SURRY POWER STATION, UNIT NO. 1

AMENDMENT TO FACILITY OPERATING LICENSE

ATTACHMENT TO LICENSE AMENDMENTS

SAFETY EVALUATION BY THE OFFICE OF NUCLEAR REACTOR REGULATION
RELATED TO AMENDMENT NO. 84 TO FACILITY OPERATING LICENSE NO. DPR-32
AND AMENDMENT NO. 85 TO FACILITY OPERATING LICENSE NO. DPR-37

FIGURE 5.4-1

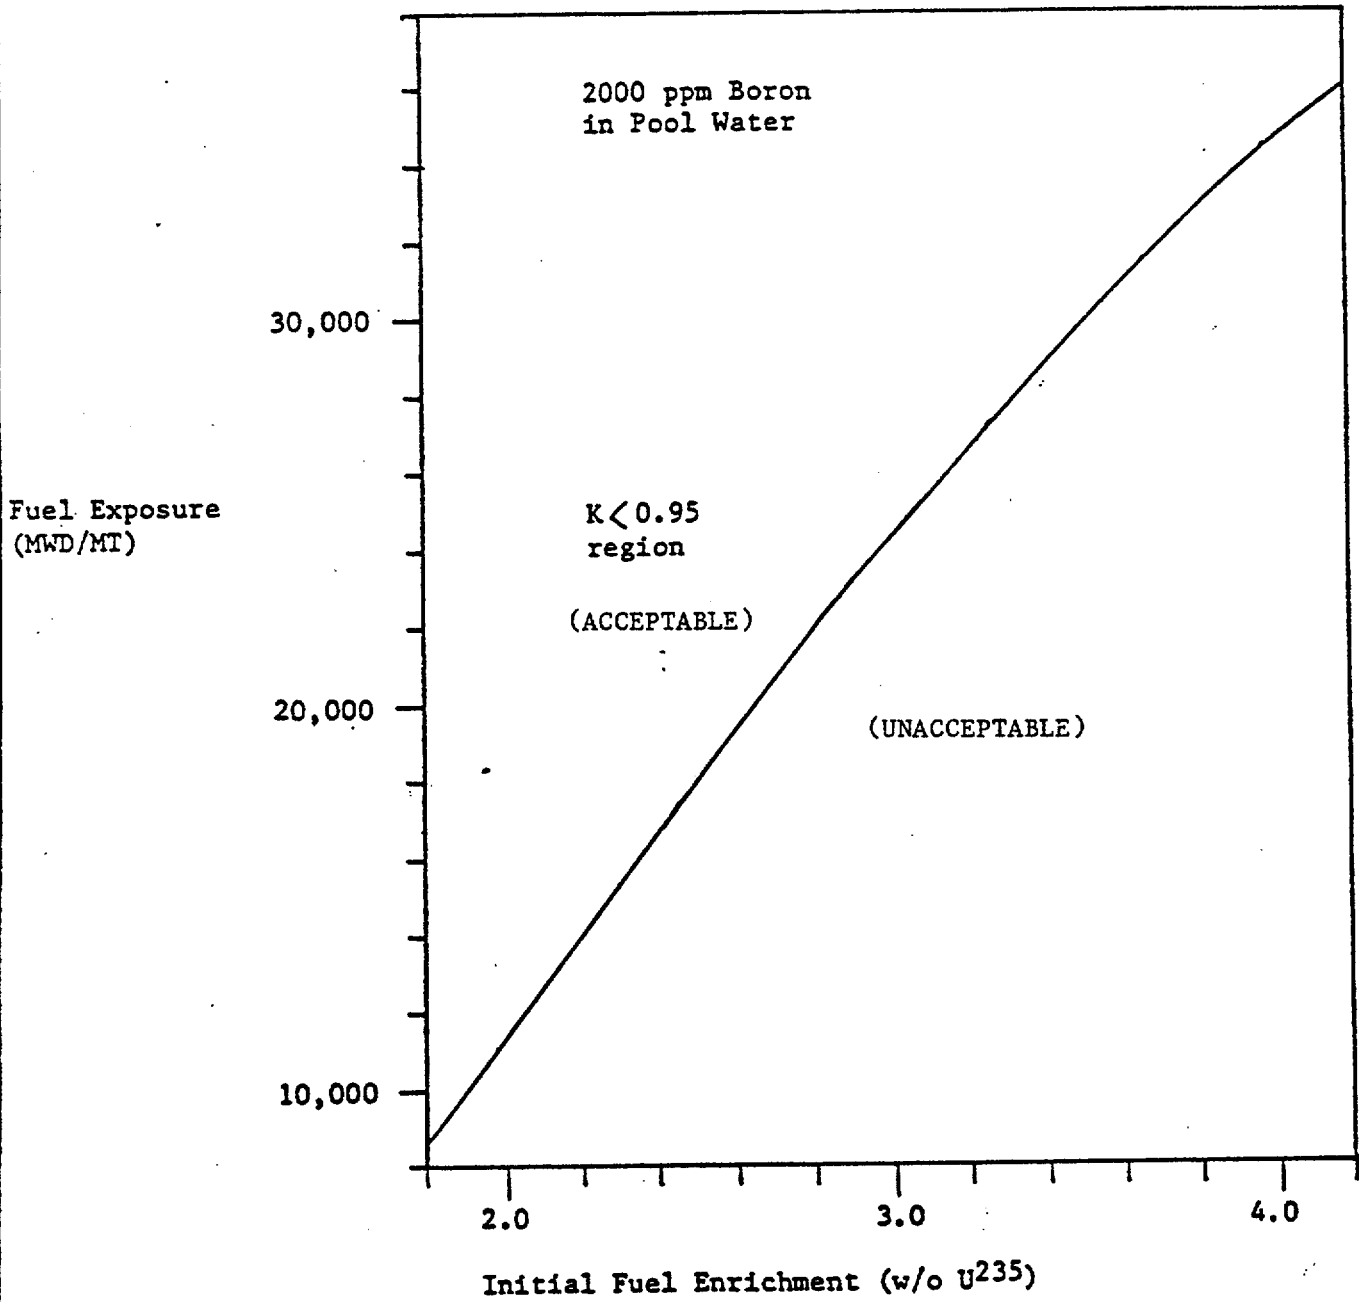
<u>Remove Pages</u>	<u>Insert Pages</u>
3.10-4	3.10-4
5.4-2	5.4-2
-----	Figure 5.4-1

assemblies to assure k_{eff} 0.95, even if unborated water were used to fill the spent fuel storage pit. The spent fuel pool is divided into a two-region storage pool. Region 1 comprises the first three rows of fuel racks (324 storage locations) adjacent to the Fuel Building Trolley Load Block. Region 2 comprises the remainder of the fuel racks in the fuel pool. During spent fuel cask handling, Region 1 is limited to storage of spent fuel assemblies which have decayed at least 150 days after discharge and shall be restricted to those assemblies in the "acceptable" domain of Figure 5.4-1. Administrative controls with written procedures will be employed in the selection and placement of these assemblies. The enrichment of the fuel stored in the spent fuel racks shall not exceed 4.1% weight percent of U-235.
